R07LH

Blue Bird Corporation has decided that a defect which relates to motor vehicle safety exists in certain 2007 through 2008 model year Blue Bird "Vision" conventional school buses manufactured from October 16, 2006 through January 18, 2007.

# BBCV Wiper/Washer Wiring

# RECALL

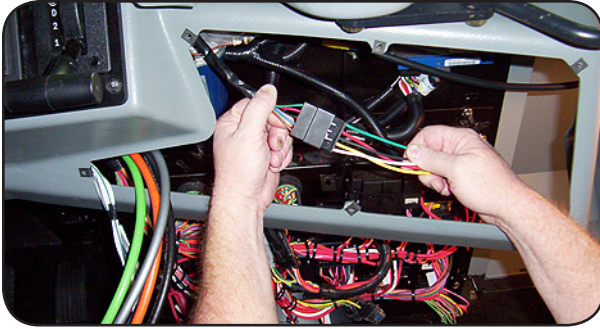
**3** Install new harness assembly 0115551:

3.1 Locate the wiring for the windshield wiper motor.
